Work Order ID 130452

Item ID: D3394-1RG Accept ***N900040100*** Setup Start ***NS1***
 Revision ID: Stop ***NS2***
 Item Name: Lug
 Start Date: 3/11/2015 Start Qty: 120.00 ***120*** Cust Item ID:
 Required Date: 3/27/2015 Req'd Qty: 120.00 ***120*** Customer:
 Reference:

DRAWING NO. D3394	TITLE LUG	REV. B	DART AEROSPACE USA, INC ENGINEERING ORDER		D.E.O. NO. D3394-B-2	SHEET NO. SHEET 1 OF 1	SCALE NTS
DRAWN GP	CHECKED SC	MFG. APPR. M	APPROVED MP		DE APPR. H		
DATE 11.05.02	DATE 11.05.09	DATE 11.05.08	DATE 11.05.08		DATE 11.05.09

D3394-1RG LUG (SHOWN)
D3394-3RG/-5RG LUGS (SIMILAR)
D3394-041RG/-043RG/-045RG LUG ASSEMBLIES (SIMILAR)

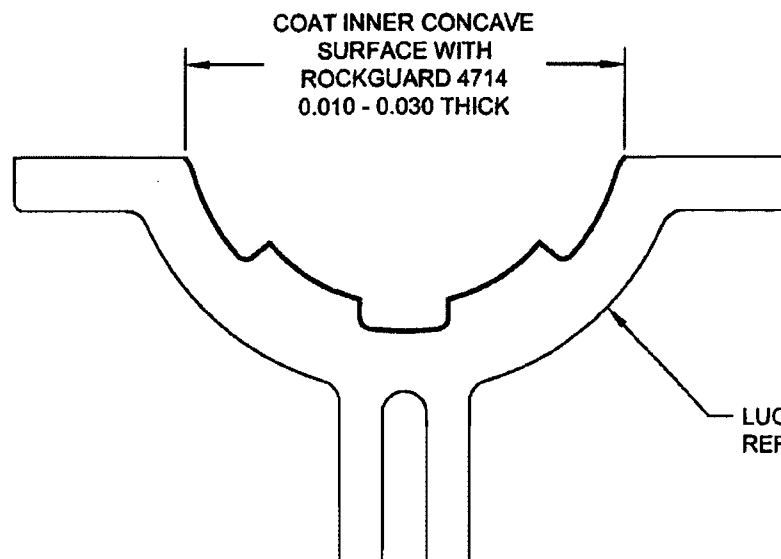
ADD D3394-xRG OPTION

D3394-xRG MOUNTING LUGS ARE INDENTICAL TO D3394-x MOUNTING LUGS, HOWEVER AFTER FINISH, COAT INNER CONCAVE SURFACE WITH "PLUS ONE ROCKGUARD 4714" AS SHOWN BELOW.
